PRODUCT/PROCESS CHANGE NOTICE (PCN)

PCN #: A0808-02R2 DATE: 25-Aug-2010 Product Affected: VFQFP-N-64 and VFQFP-N-72 (Standard and Green) Date Effective: 27-Sep-2008	MEANS OF DISTINGUISHING CHANGED DEVICES: <input type="checkbox"/> Product Mark <input checked="" type="checkbox"/> Back Mark Lot # will have "U", "P", "D", "I", "Y" or <input type="checkbox"/> Date Code "CH" prefix. <input type="checkbox"/> Other
------------------------------------------------------------------------------------------------------------------------------------------------------------------------------------------------	---------------------------------------------------------------------------------------------------------------------------------------------------------------------------------------------------------------------------------------------------------------------------------------

ATTACHMENT I - PCN #: A0808-02R2

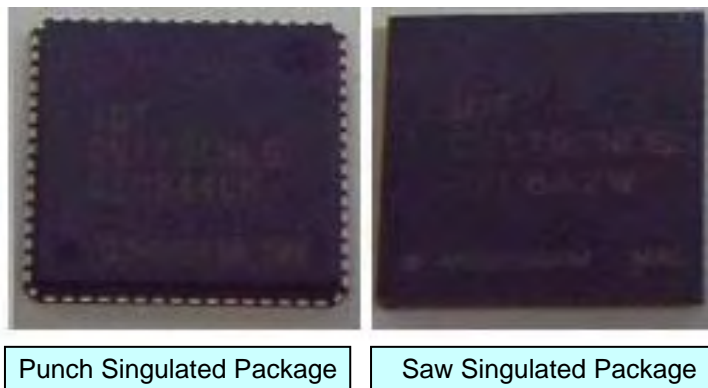
Revision 1: This revised notification is to add information that lots assembled by Chipmos, Taiwan are punch singulated. There are no changes to land pad design and moisture sensitive level. However, there is a difference in the physical appearance of the package as shown in the picture below.
